Pipeline and Hazardous Materials
Safety Administration

Reference No. 14-0180

Q1. What is the definition of "similar reflecting color" as specified in § 178.337-1(d)(4)?

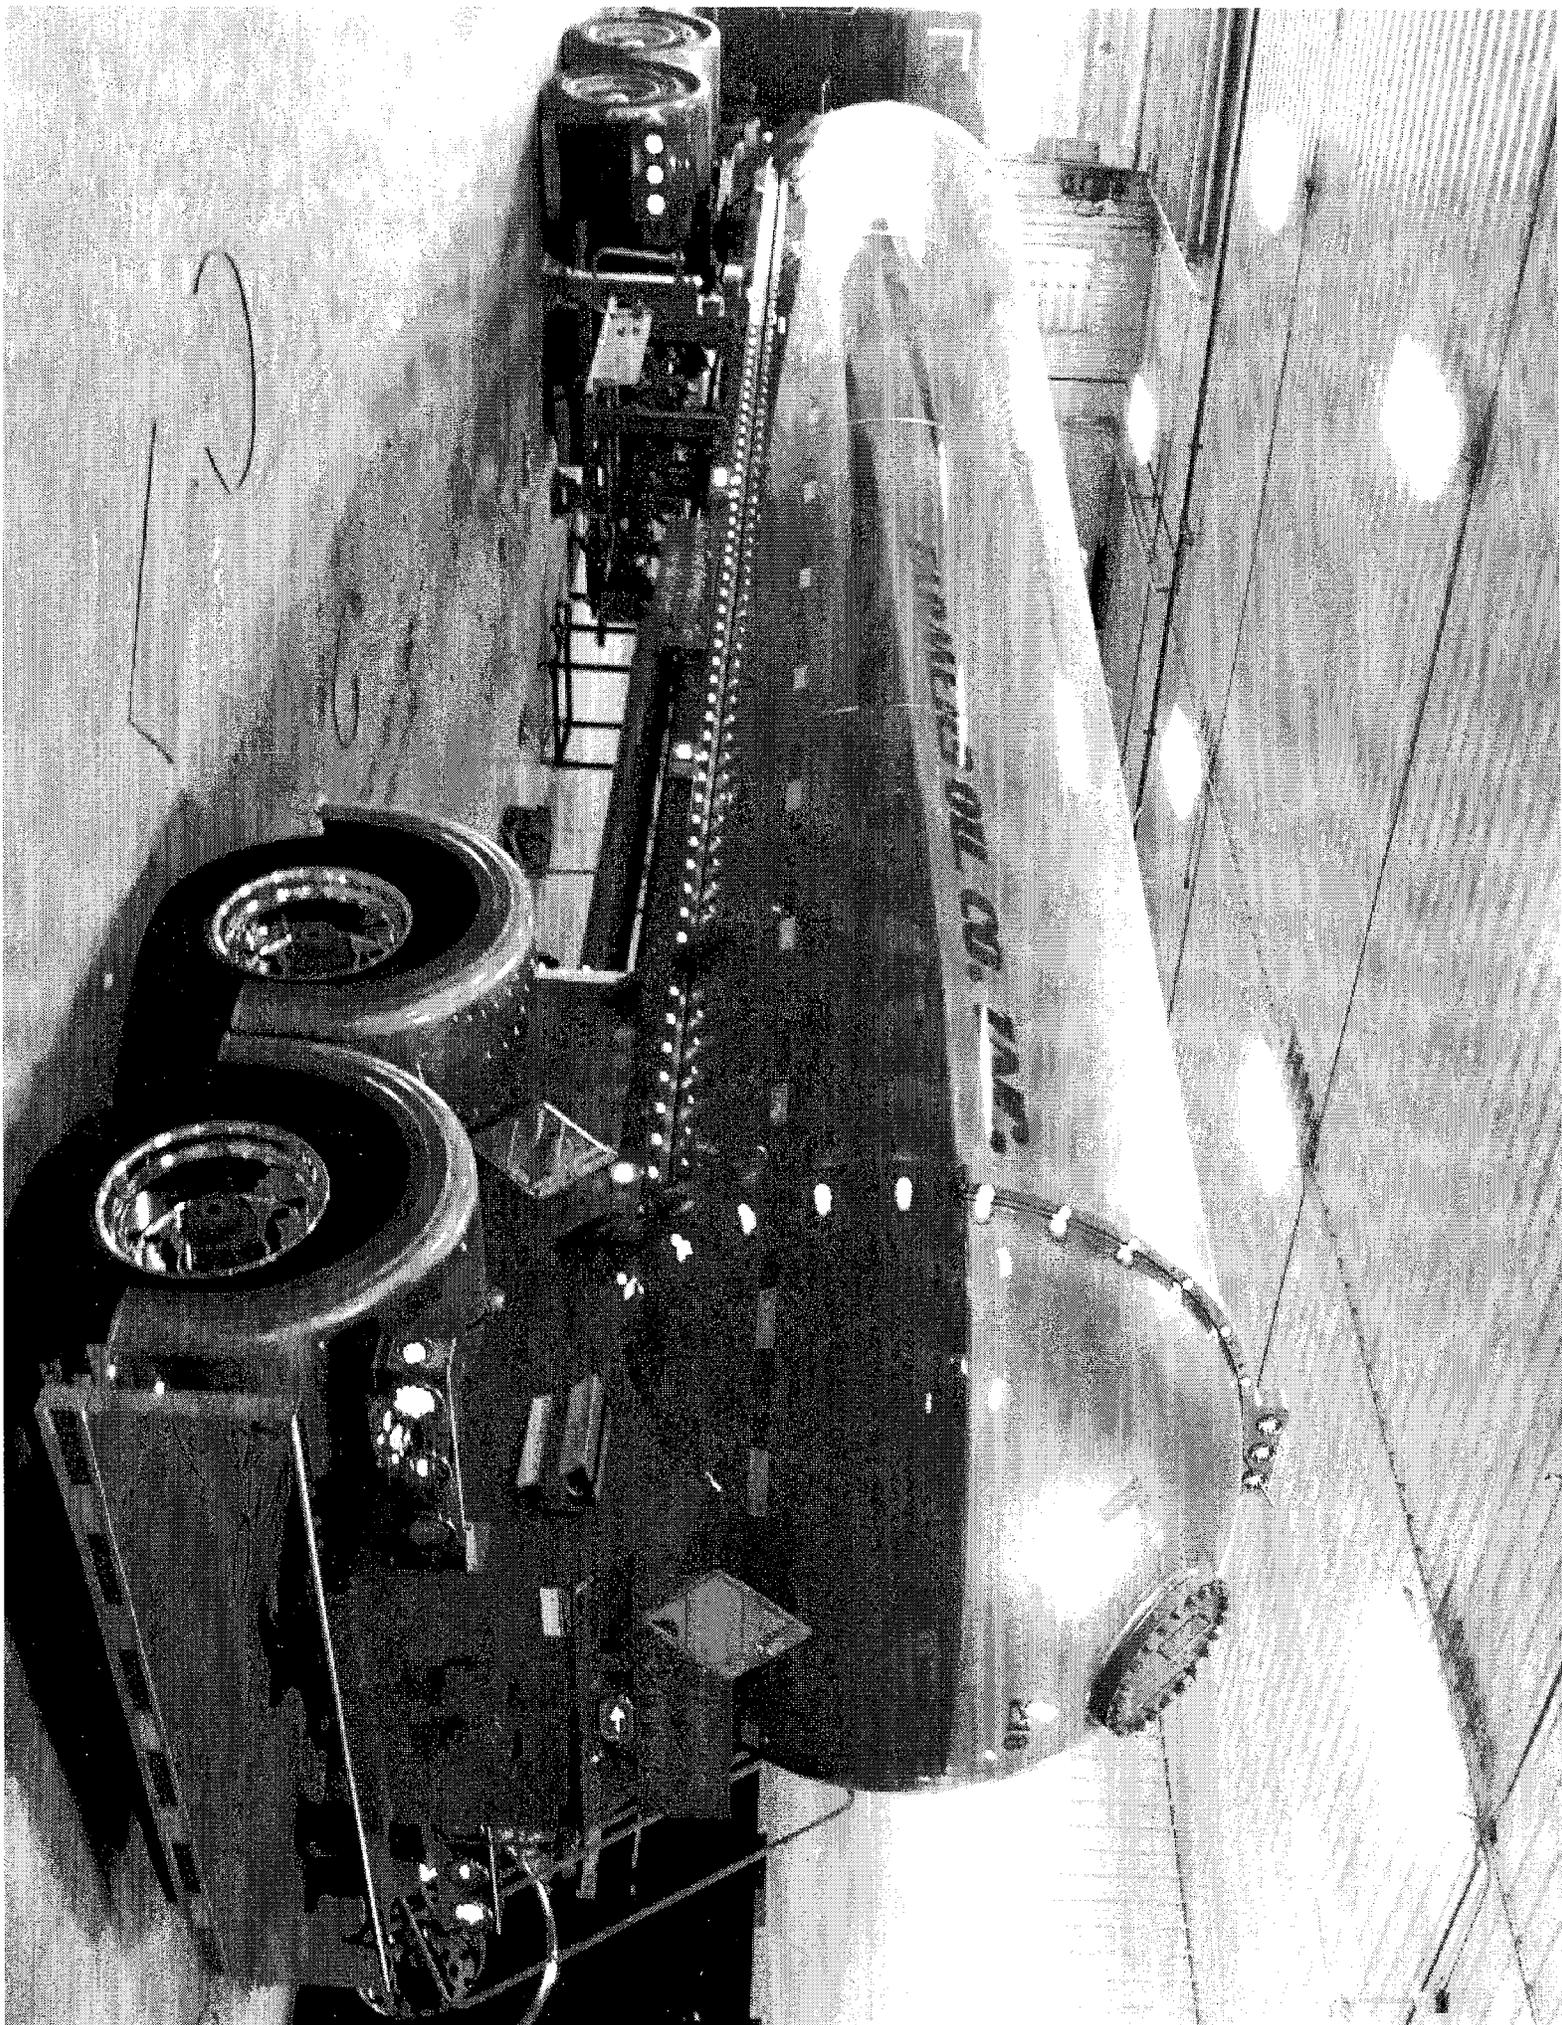
Q3. Is the trailer color scheme presented in conformance with the requirements of the HMR?

- 1) What is the definition of "similar reflecting color"
- 2) Are there specific paint properties and/or colors that you can provide us with so that we can be assured we meet code? (code is specific that white and aluminum colors are adequate, but what about the "similar reflecting color")
- 3) The images the customer has provided me with, has the orange or red "flame" on the upper two-thirds of the trailer in addition to the same color extending to the entire bottom half of the rear head and rear 1/3 of the shell . In this case, is the trailer compliant with code because the orange or red passes the "similar reflecting color"?

A3. It is the opinion of this Office that since the majority of the color on the upper two thirds of the cargo tank is white or silver and that there is a limited amount of the light orange/red color, that the paint scheme on the cargo tank would be in compliance with § 178.337-1(4)(d).
